**INTERNATIONAL CODE COUNCIL
2012/2013 CODE DEVELOPMENT CYCLE
Group A (2012)**

**PROPOSED CHANGES TO THE
2012 EDITIONS OF THE**

INTERNATIONAL BUILDING CODE®

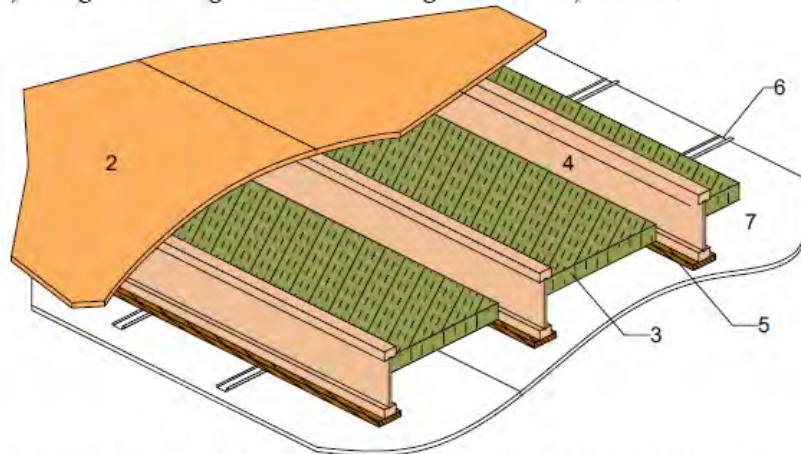
Reason: The changes proposed here are editorial. The original publication of this entry contained typographical errors such as rounding the minimum flange cross-sectional area to 2.3 cubic inches from the original submitted text of 2.25 cubic inches. Other changes are simply to clean up language involving nominal dimension or actual dimension and other nontechnical issues. In Item 27, the minimum required length of the drywall screws was incorrectly entered as 1-5/8inch when the actual minimum is 1-1/4inch.

FIGURE 722.5.1(2)

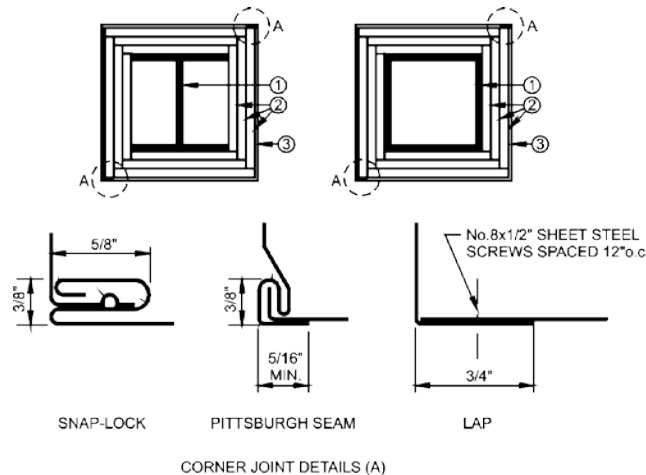
722.5.1.2.1 Attachment. The gypsum ~~wallboard~~ board or gypsum panel products shall be supported as illustrated in either Figure 722.5.1(2) for fire-resistance ratings of 4 hours or less, or Figure 722.5.1(3) for fire-resistance ratings of 3 hours or less.

FIGURE 722.5.1(3)
GYPSON WALLBOARD PROTECTED STRUCTURAL STEEL COLUMNS WITH STEEL
STUD/SCREW ATTACHMENT SYSTEM

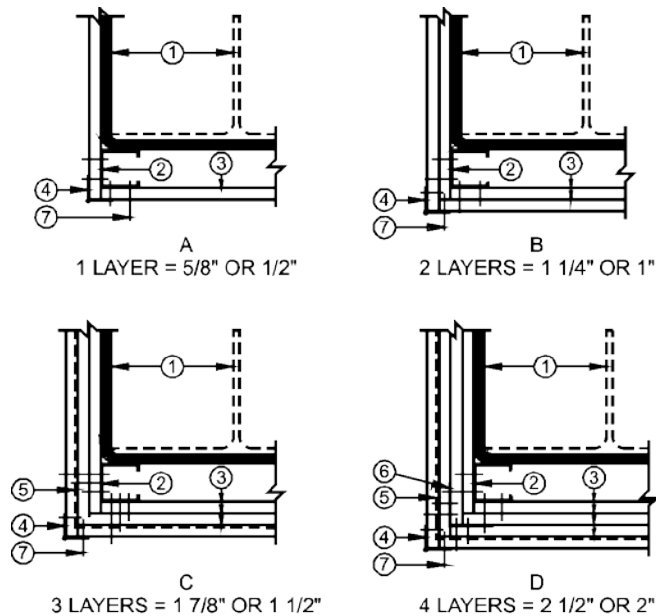
1. As a single layer with no horizontal joints.
 2. As multiple layers with no horizontal joints permitted in any layer.
 3. As multiple layers with horizontal joints staggered not less than 12 inches vertically between layers and not less than 8 feet vertically in any single layer. For single-layer applications, the wallboard shall be applied vertically with no horizontal joints. For multiple-layer applications, horizontal joints are permitted at a minimum spacing of 8 feet, provided that the joints in successive layers are staggered at least 12 inches. The total required thickness of wallboard gypsum board or gypsum panel products shall be determined on the basis of the specified fire-resistance rating and the weight-to-heated-perimeter ratio (W/D) of the column. For fire-resistance ratings of 2 hours or less, one of the required layers of gypsum wallboard board or gypsum panel product may be applied to the exterior of the sheet steel column covers with 1-inch long Type S screws spaced 1 inch from the wallboard edge and 8 inches on center. For such installations, 0.0149-inch minimum thickness galvanized steel corner beads with 1 1/2-inch legs shall be attached to the wallboard with Type S screws spaced 12 inches on center.

3. For fire-resistance ratings of 3 hours or less, the column covers shall be fabricated from 0.0239-inch minimum thickness galvanized or stainless steel. For 4-hour fire-resistance ratings, the column covers shall be fabricated from 0.0239-inch minimum thickness stainless steel. The column covers shall be erected with the Snap Lock or Pittsburgh joint details. For fire-resistance ratings of 2 hours or less, column covers fabricated from 0.0269-inch minimum thickness galvanized or stainless steel shall be permitted to be erected with lap joints. The lap joints shall be permitted to be located anywhere around the perimeter of the column cover. The lap joints shall be secured with 1/2-inch-long No. 8 sheet metal screws spaced 12 inches on center. The column covers shall be provided with a minimum expansion clearance of 1/8 inch per linear foot between the ends of the cover and any restraining construction.

FIGURE L102.3

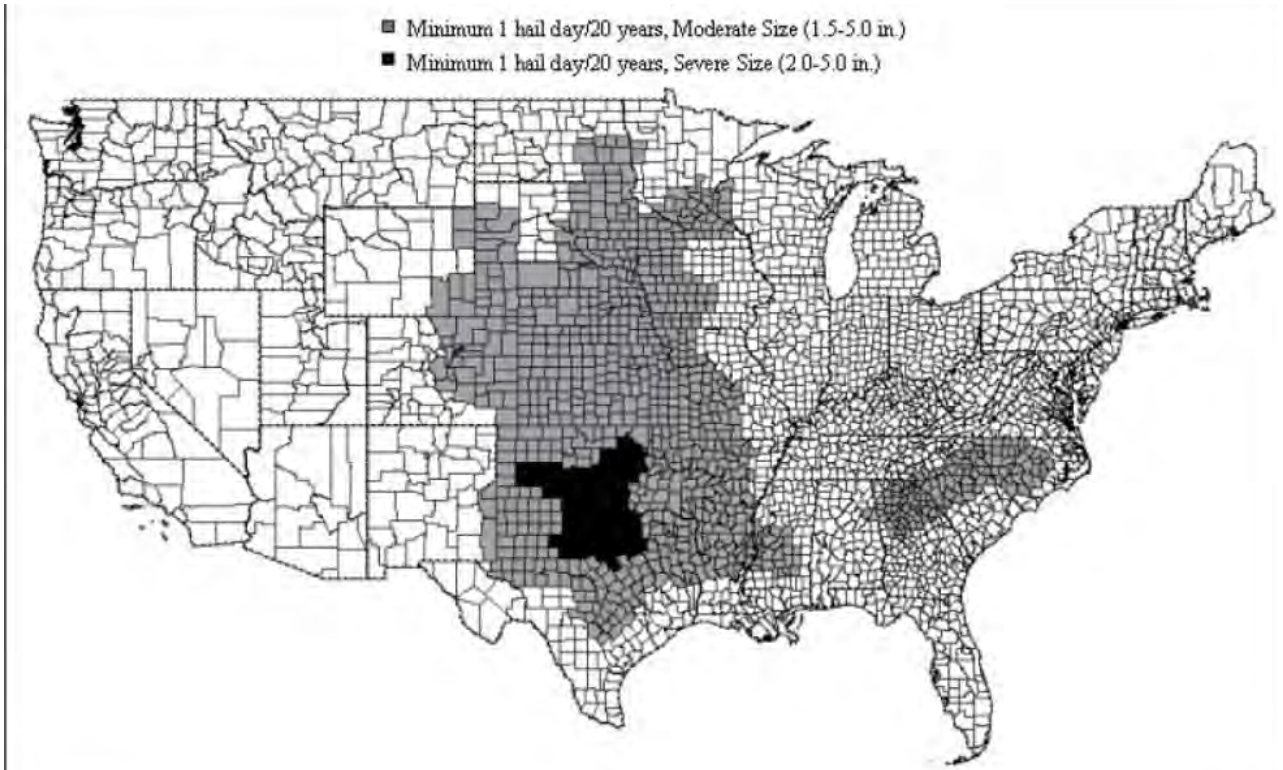
L102.3.2 Exterior wall coverings subject to hail exposure. Wall coverings used in regions where hail exposure is Moderate or Severe, as determined in accordance with Section L102.3.1 and Figure L102.3, shall be tested, classified, and labeled in accordance with UL 2218 or FM 4473.

L103.4 Roof coverings subject to hail exposure. Roof coverings used in regions where hail exposure is Moderate or Severe, as determined in accordance with Section L103.4.1 and Figure L102.3, shall be tested, classified, and labeled in accordance with UL 2218 or FM 4473.
